## **ARLINGTON COUNTY, VIRGINIA**

Permit Holder	
Contractor	
Type of Work	Commercial Alteration
Brief Description of Work	INTERIOR ALTERATION- TENANT EXPANSION
Code Cycle	2012

RE: 1001 19<sup>th</sup> Street – Insight Global Permit Comment Response GHT project # 18808728 Permit # B1701636 Project ID # CTBO-3890

11TH FLR EGRESS PLAN

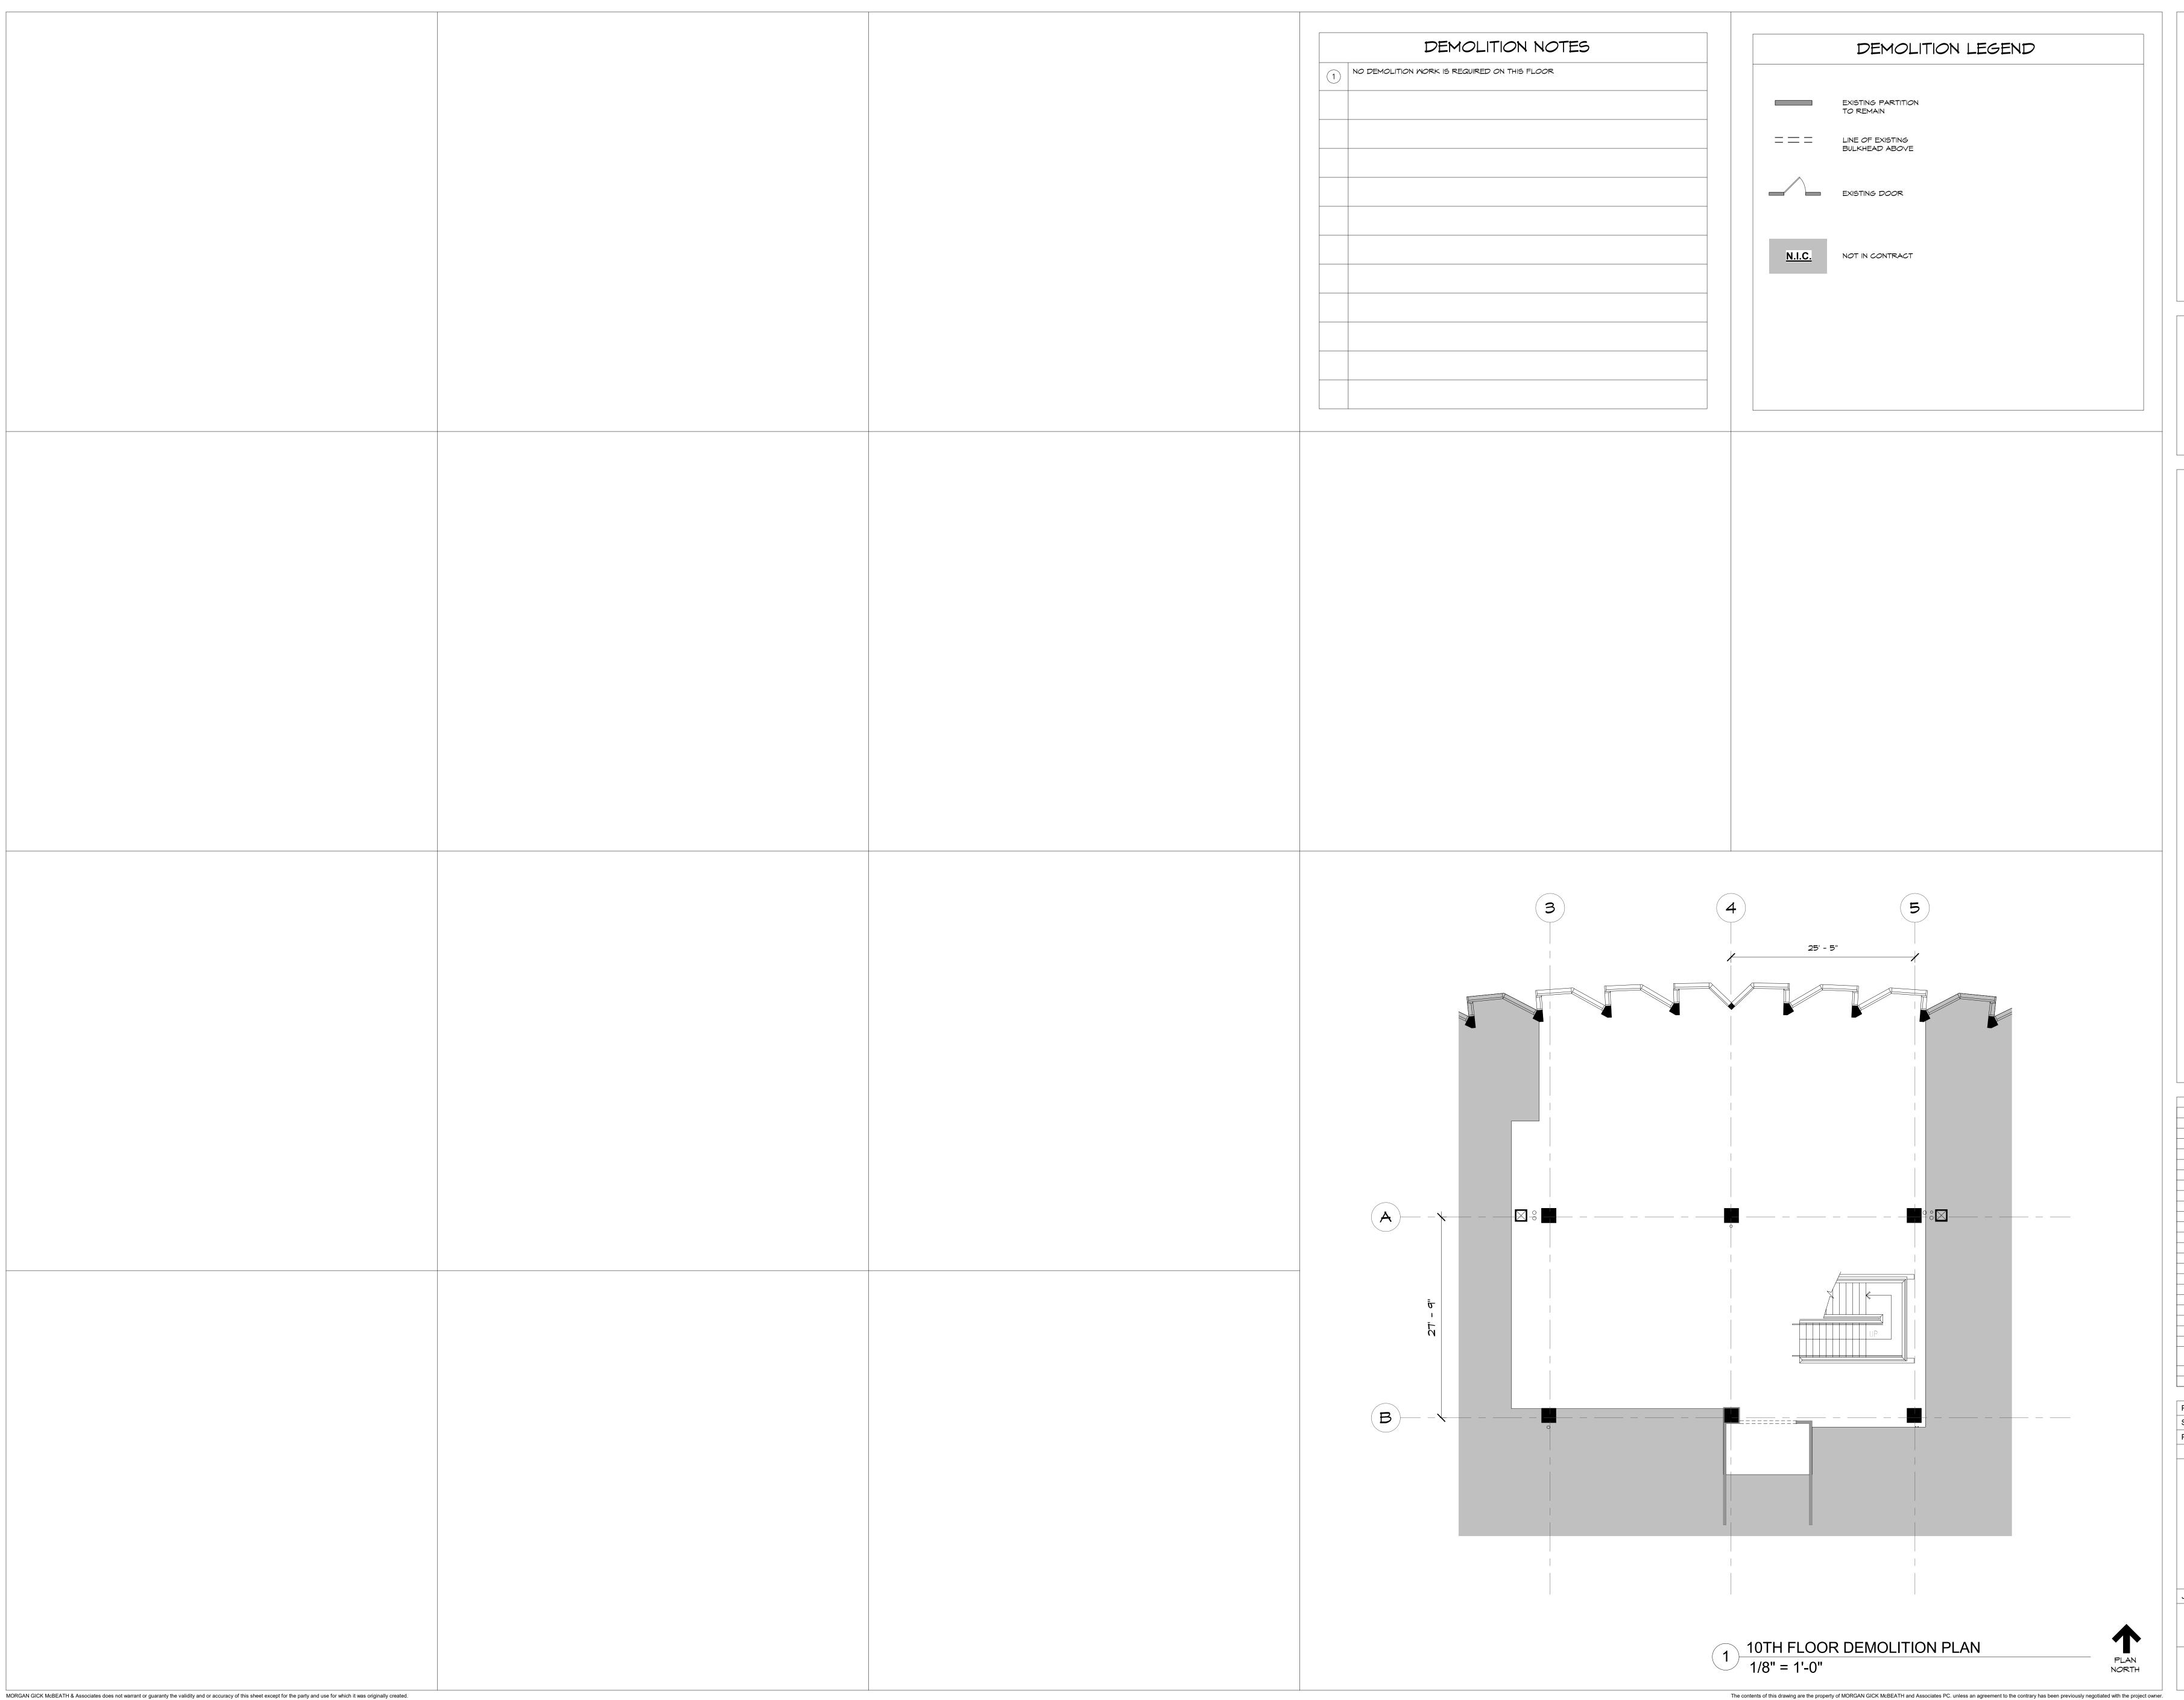
3. "A3-0-11 11 Floor Egress Plan - 18 July 2017: Please note that the maximum diagonal (diameter of smallest circumscribed circle around the space being considered) is somewhat longer than the diagonal shown on the drawing. VCC 1015.2.1."

Response: TA3.0-11, the diagonal for the floor has been revised to the furthest points.

10TH FLOOR CONSTRUCTION PLAN

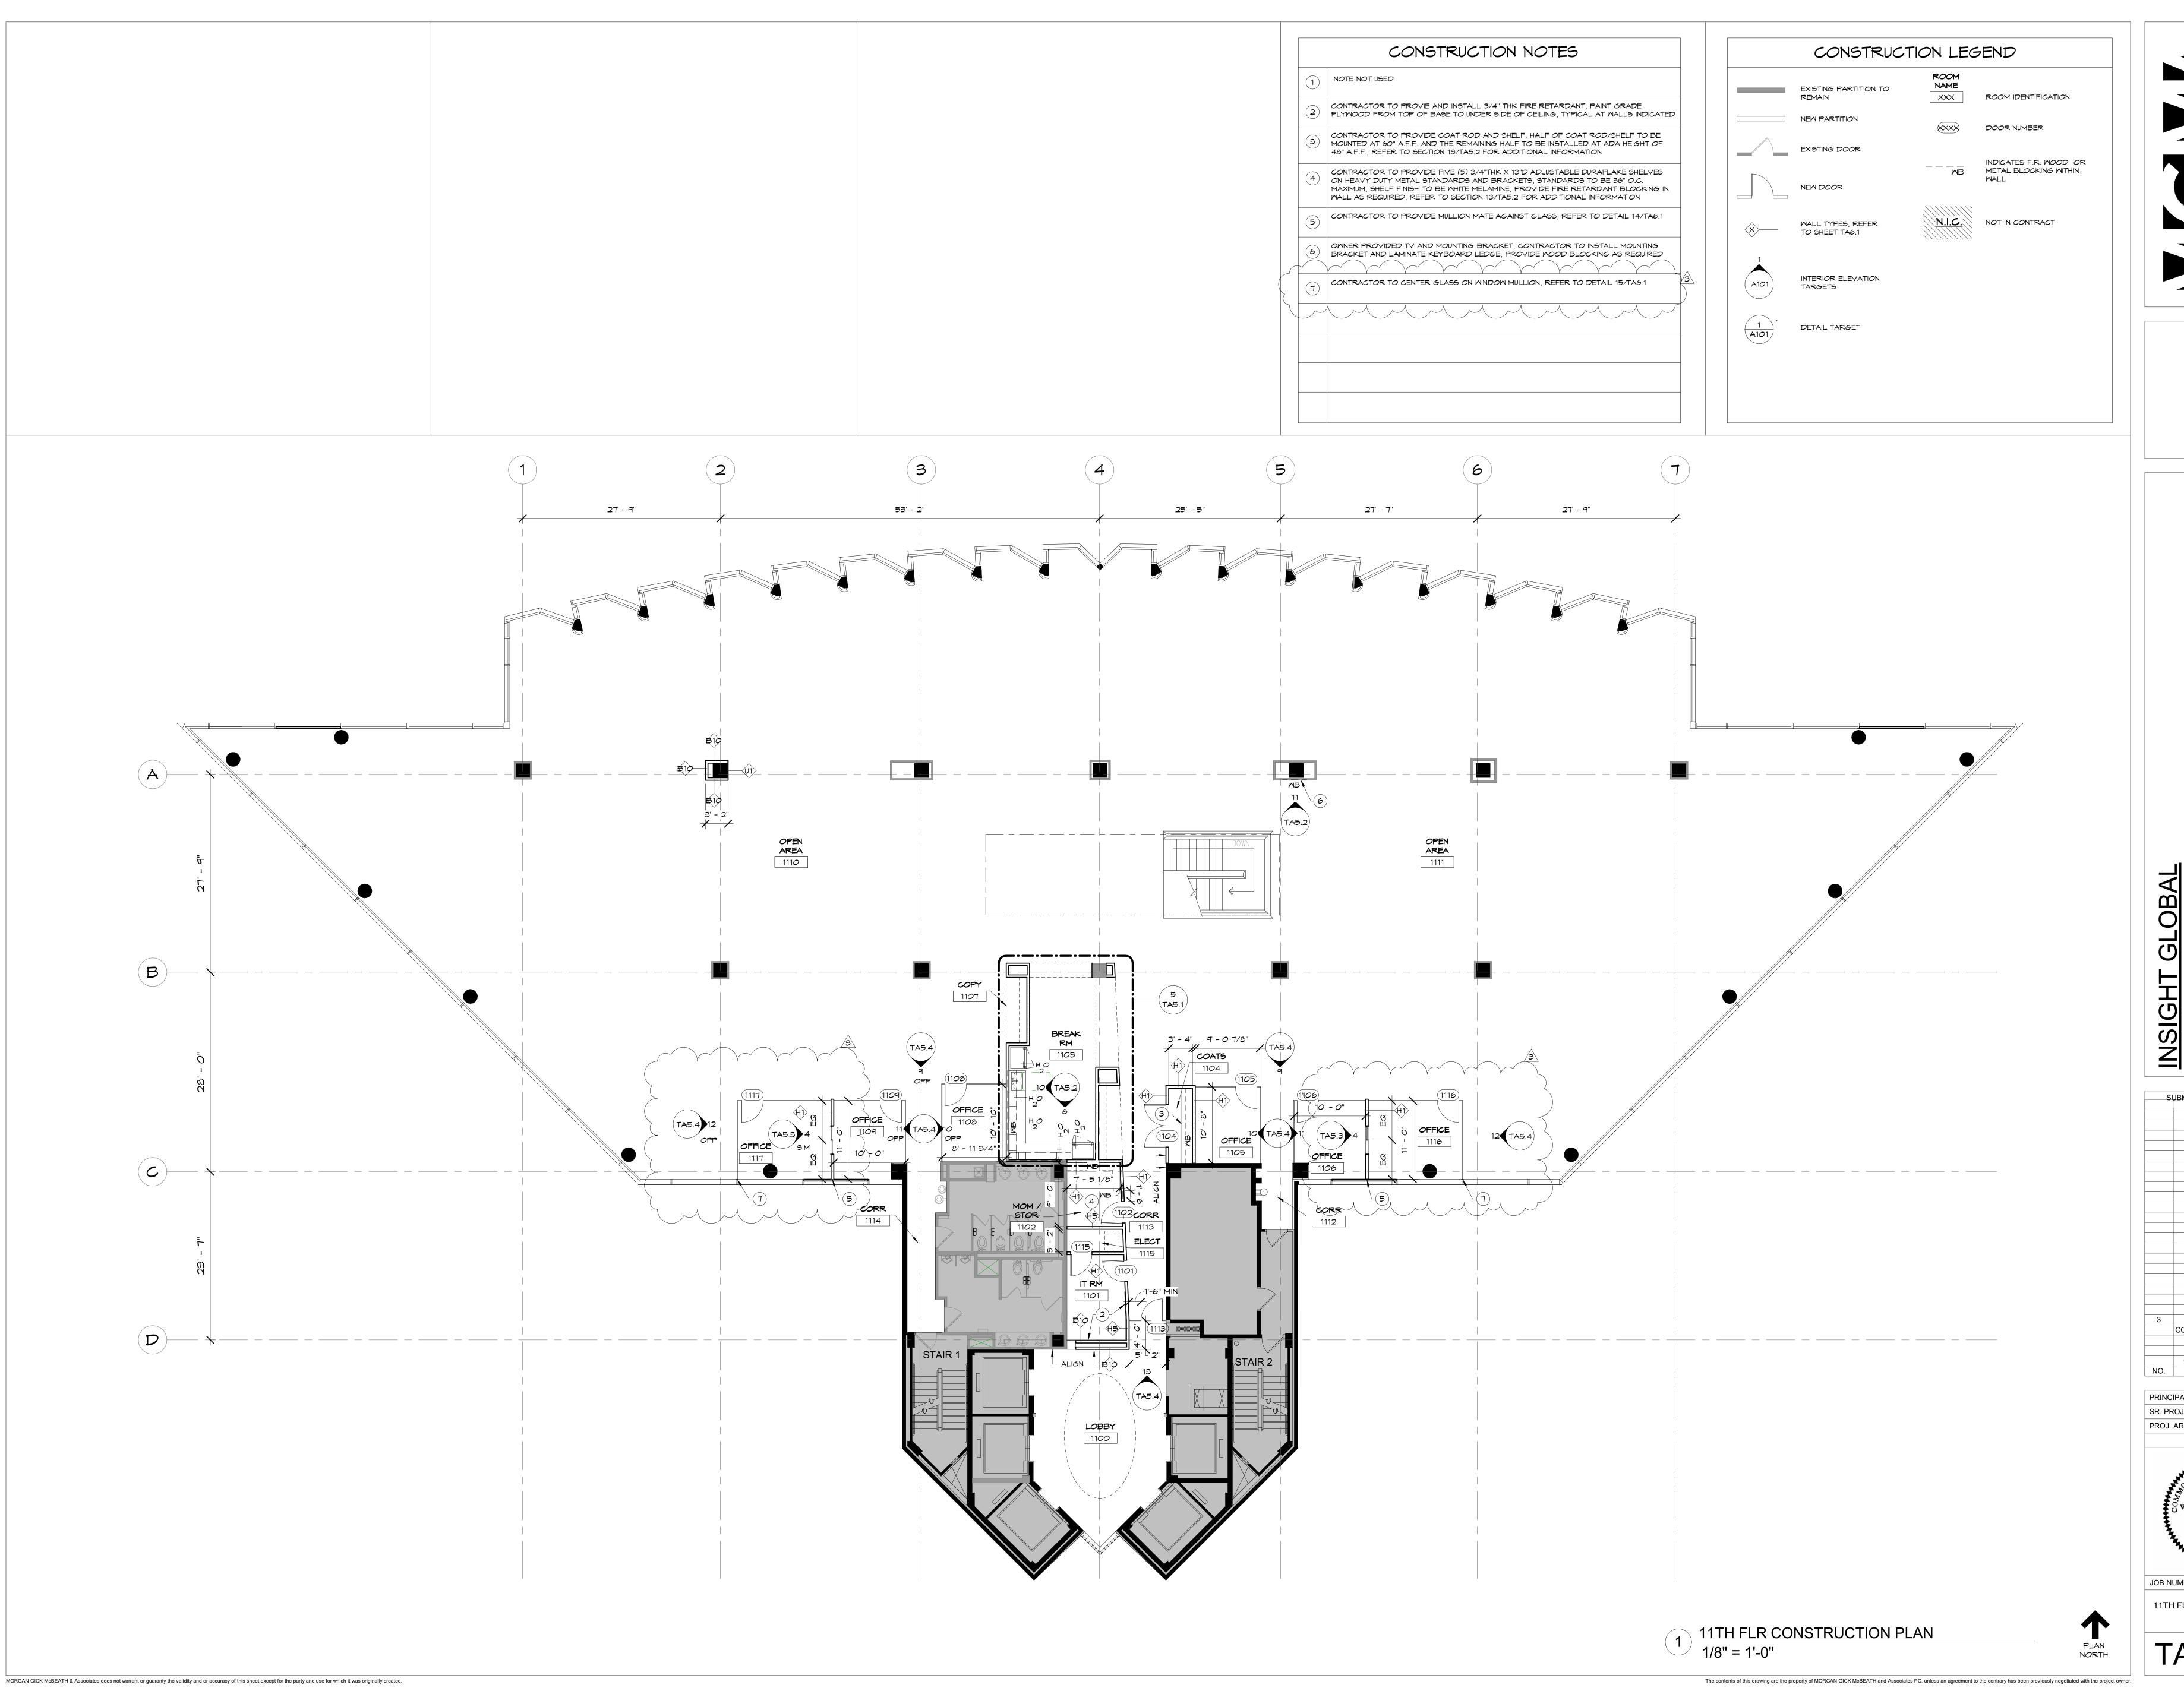
1. "Sheet A3-2-10 – 10<sup>th</sup> Floor Construction Plan appears to be missing."

**Response:** The 10<sup>th</sup> Floor Construction Plan is not included as it is not part of the revision scope of work.

10TH FLOOR POWER/SIGNAL PLAN

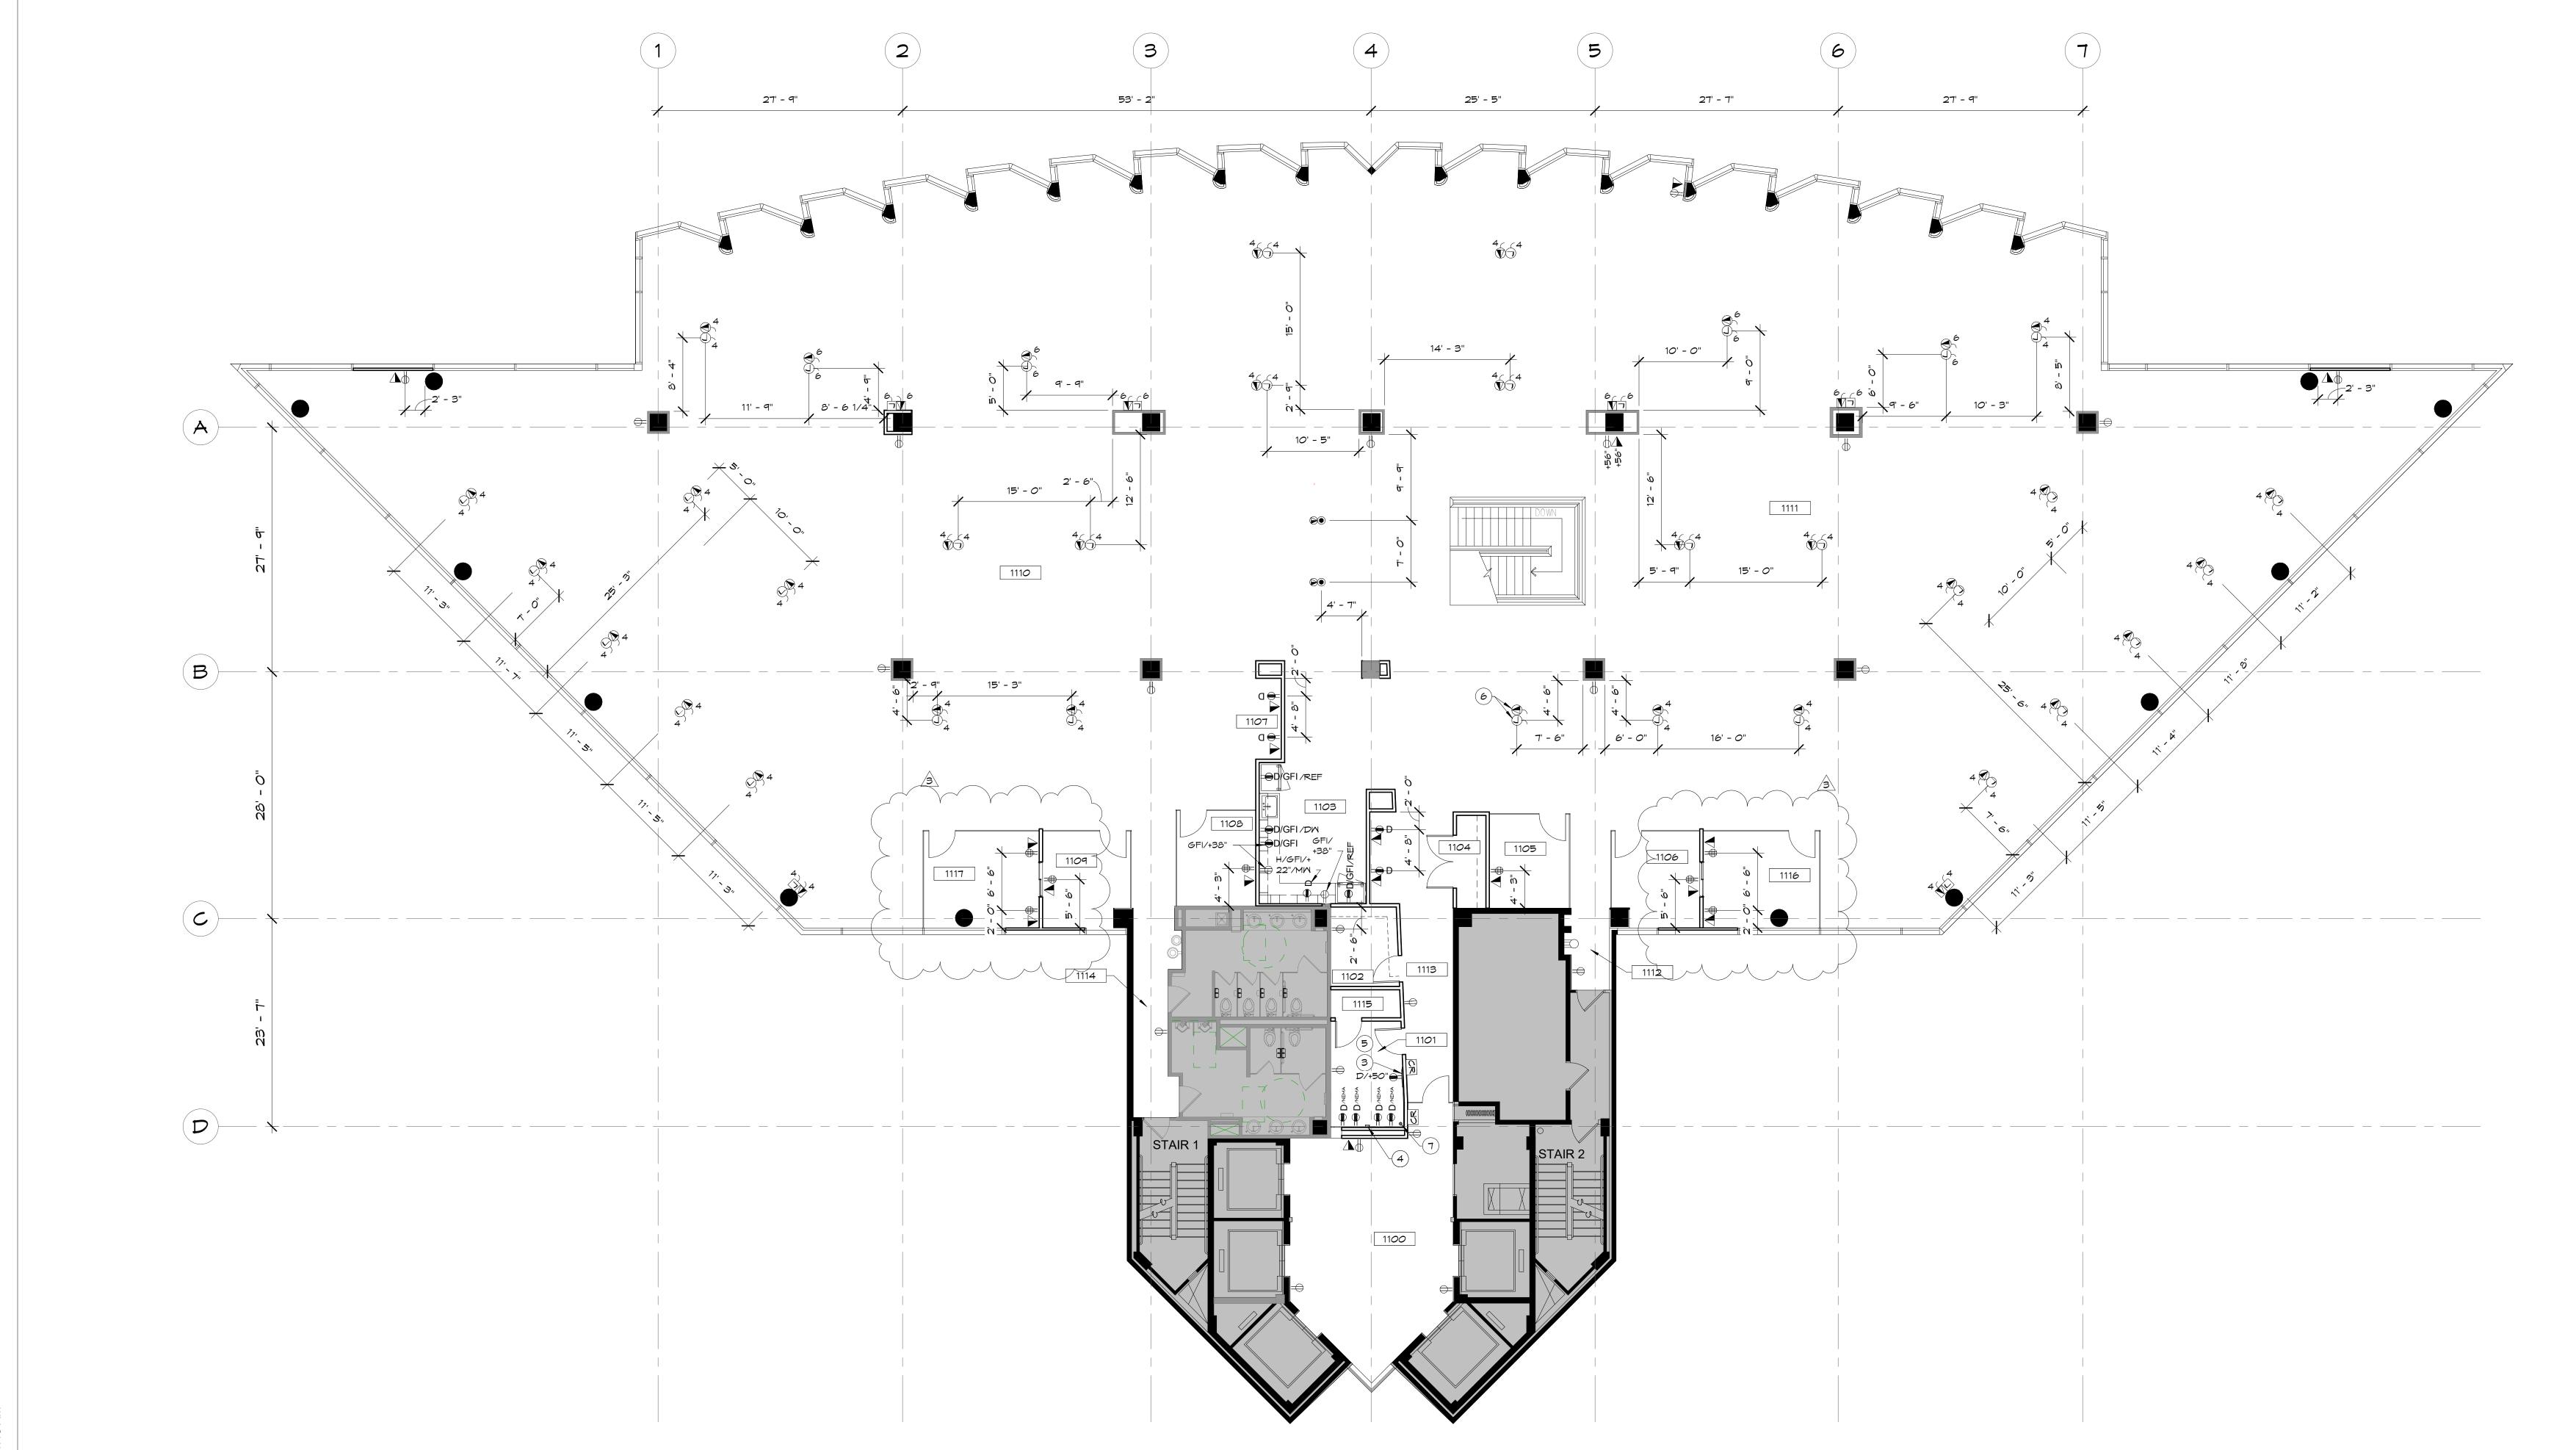
4. "A3-3-10 10<sup>th</sup> Floor Power Signal Plan – 18 July 2017: The sink in Pantry [1018] is not accessible as shown. See sheet A5-3, Detail 5. 2009 ANSI A117.1 606.2; 305.3; 306 – Provide a forward approach. The space underneath the sink shall provide knee and toe clearances. Forward approach requires the removal of the cupboard doors under the sink – As an alternate, a parallel approach may be provided, with the prescribed clear space centered on the sink."

**Response:** TA5.3, Detail #5: the ADA knee clearance has been shown for the pantry sinks for the 10th and 11<sup>th</sup> floors. When the doors are fully open, a wheelchaired person will be able to use a forward approach to reach the sink.
